REGULATORY INFORMATION DISTRIBUTION SYSTEM (RIDS)

SUBJECT: Provides responses to questions posed by NRC during TVA/NRC
 940324 meeting in Rockville, MD re proposed approach to
 resolve vertical flexible floor issue at BNP.

**BELLEFONTE NUCLEAR PLANT (BLN) - RESPONSE TO NRC QUESTIONS ON
THE BLN VERTICAL FLEXIBLE FLOOR STUDY**

FIGURE 3-1

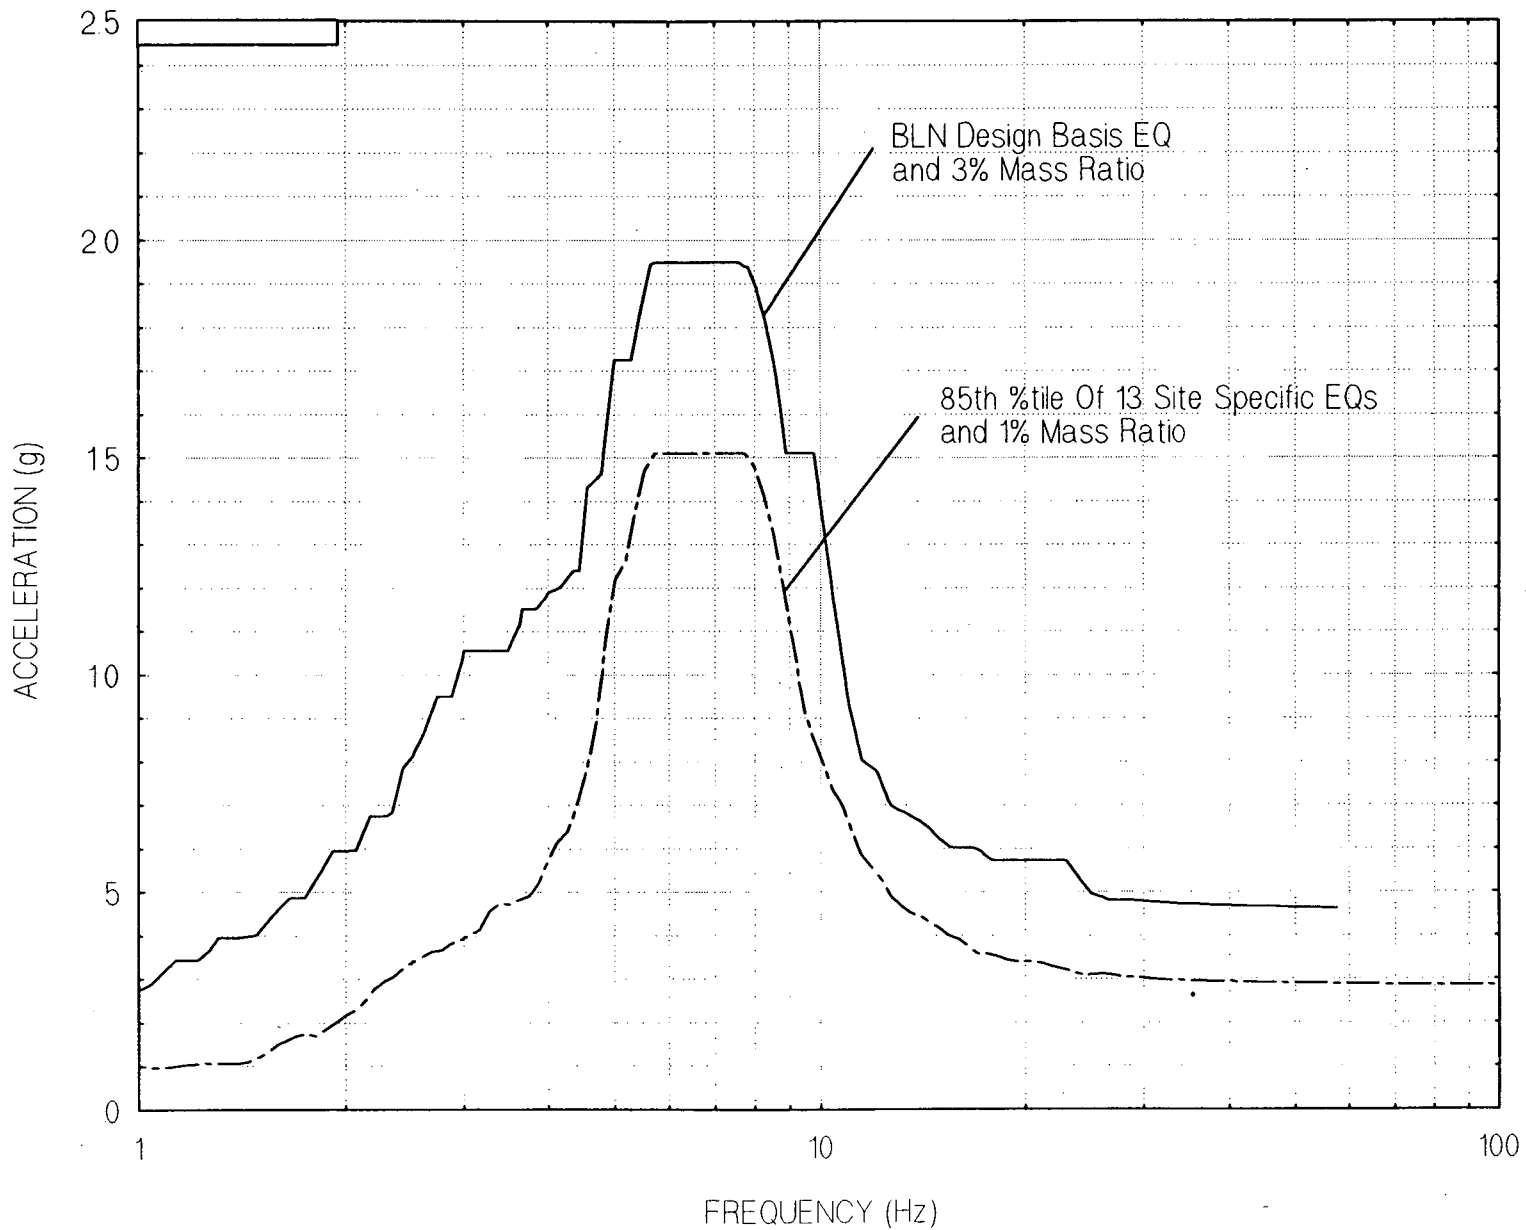
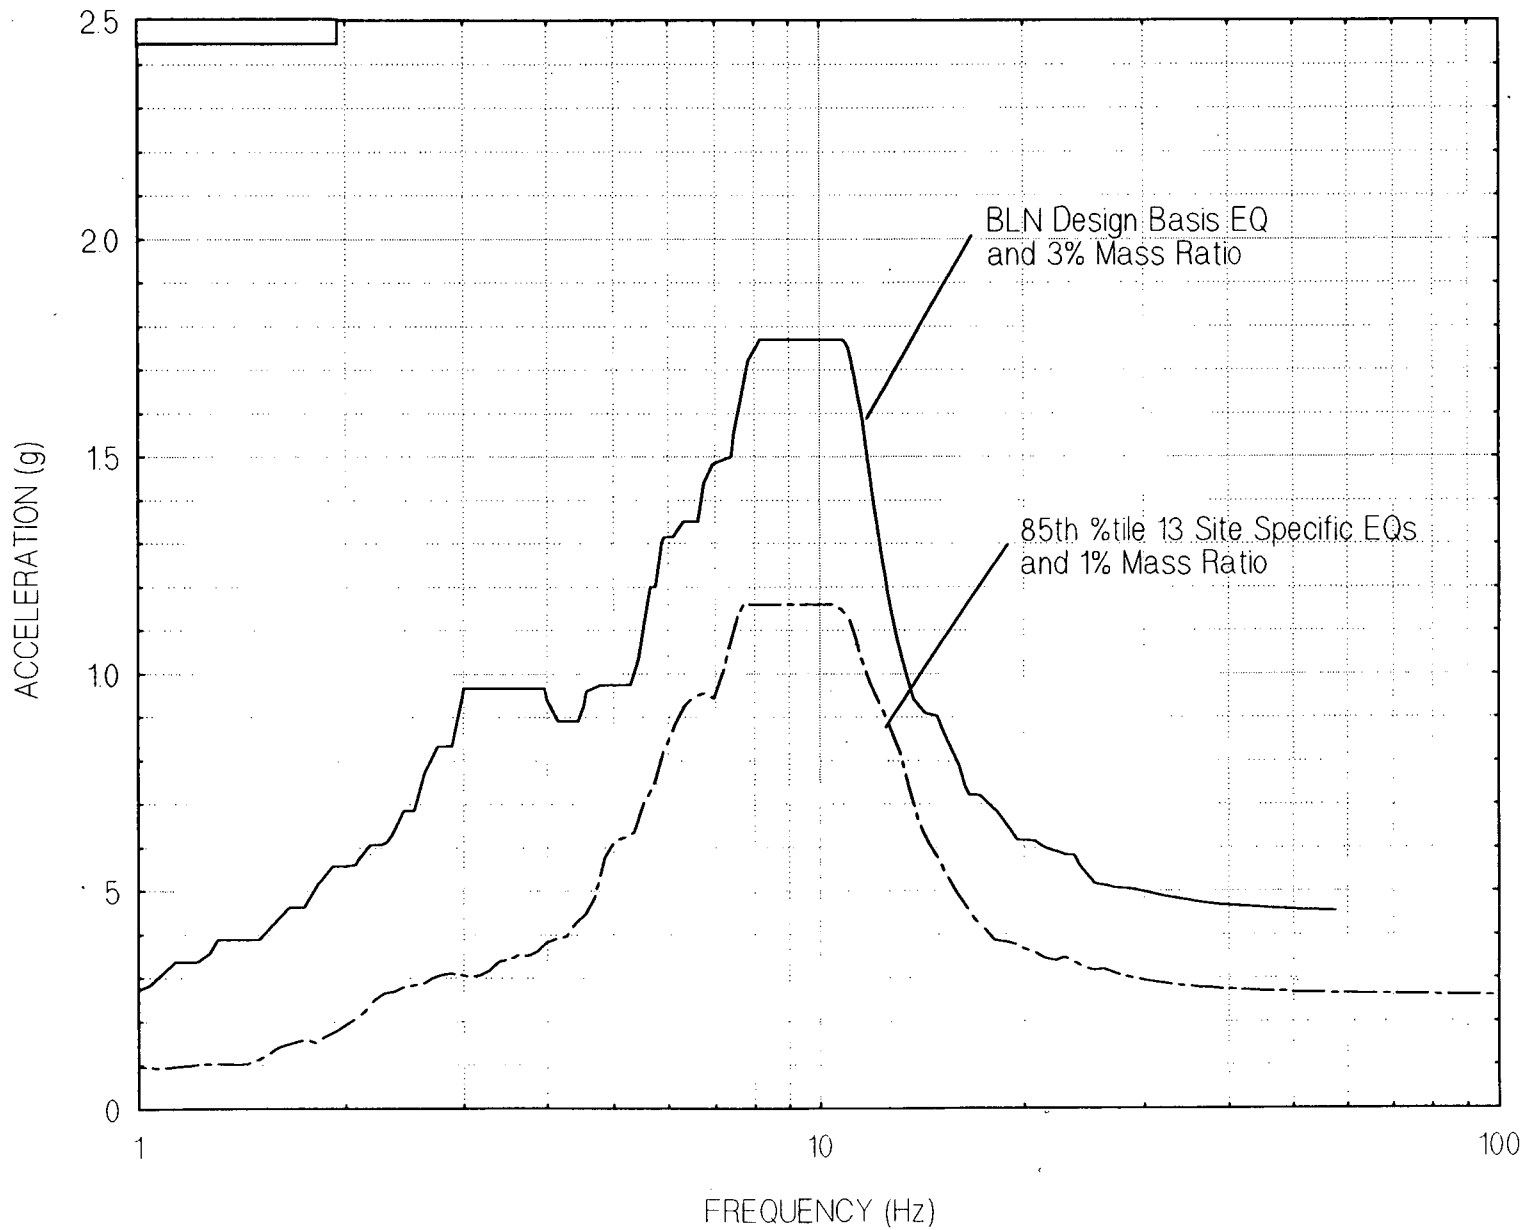
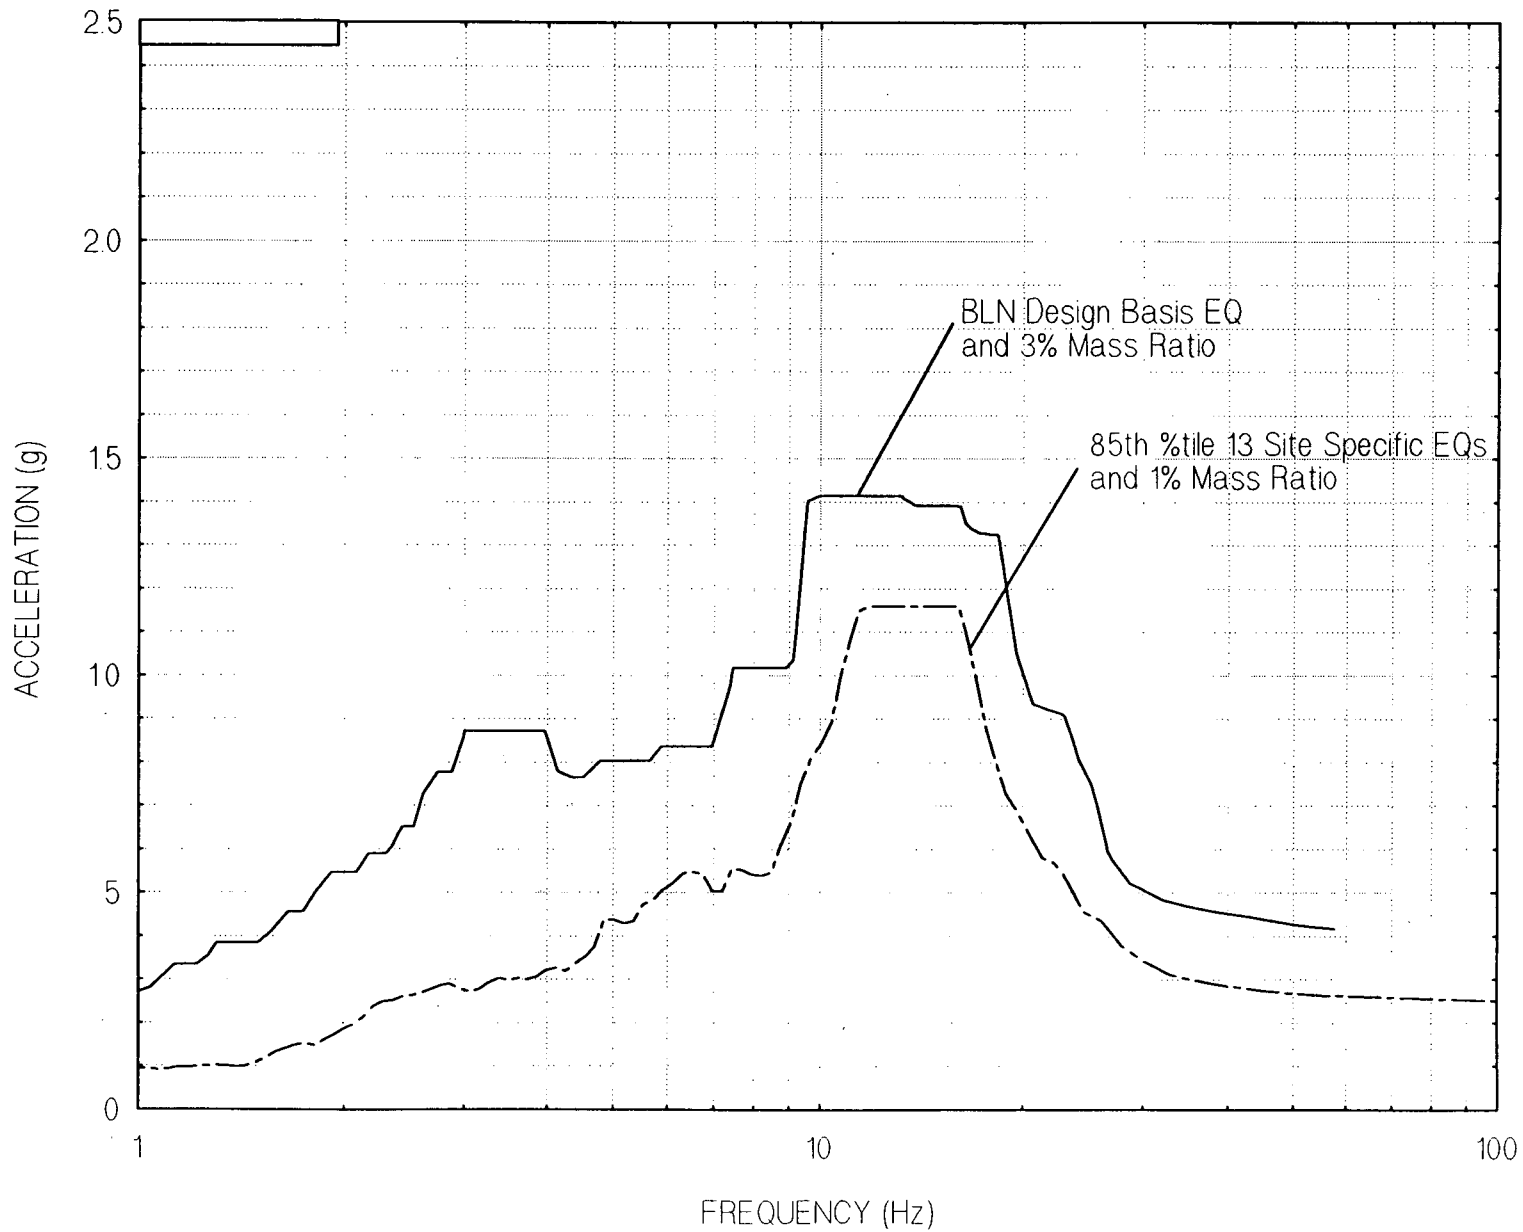
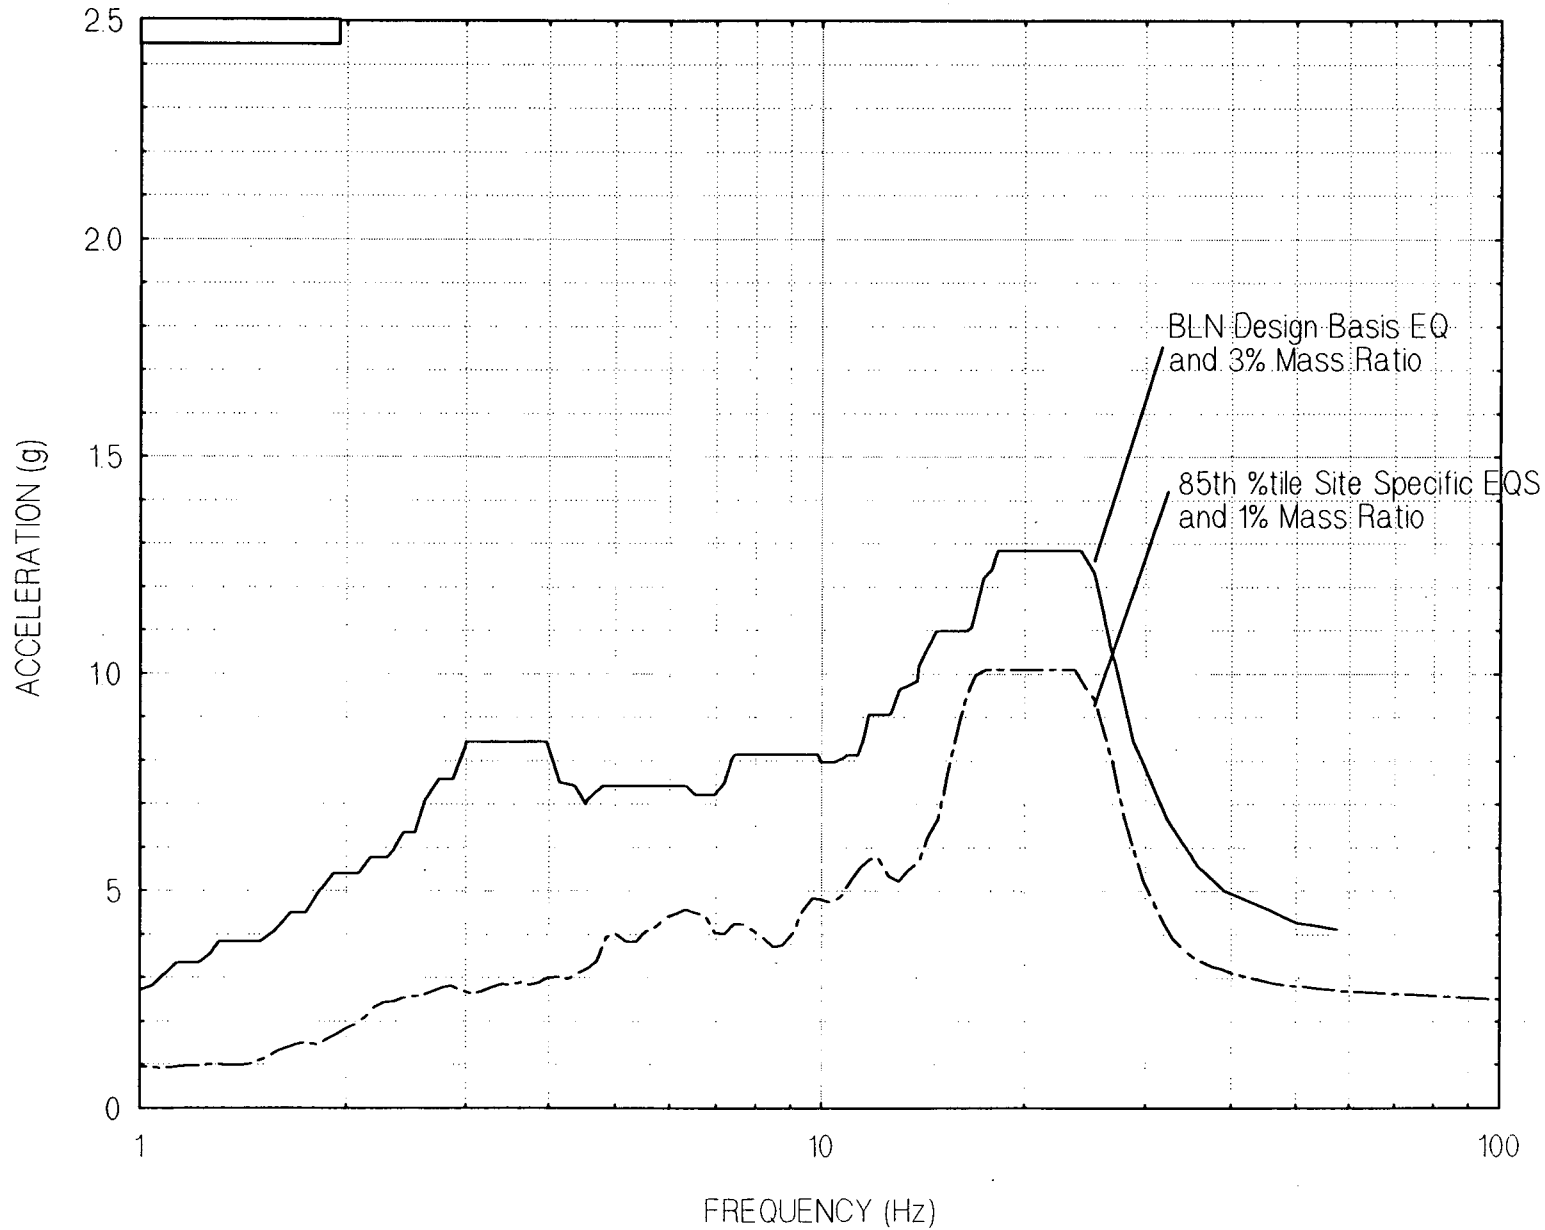
As the reduction of equipment specific FFRS are sensitive to the relative impedances (and mass ratios), the use of one mass ratio (i.e. 3%) is not justifiable. Provide a systematic procedure which would be representative of the actual equipment impedances in arriving at the vertical seismic loads on the equipment.

BLN believes that the use of a single equipment mass ratio is justified given that:

- Walkdown results of vertically flexible floors in the Auxiliary-Control Building (ACB) found actual mass ratios to vary between 0.1% to 5.6% with an average of 1.5%

- The magnitude of the FFRS reduce with increases in the mass ratio
- A mass ratio value of 1% is clearly conservative for 70% of the flexible floor slabs (i.e., the actual mass ratio is 1% or larger)

- Slabs with a mass ratios less than 1% are addressed by conservatively enveloping the 1% MR site specific FFRS.
- BLN design basis FFRS for 3% mass ratio conservatively envelop 1% mass ratio site specific FFRS (Refer to Figures 3-1 through 3.4).

- Based on the above, use of the single mass ratio (i.e., 3%), proposed by BLN is justified.
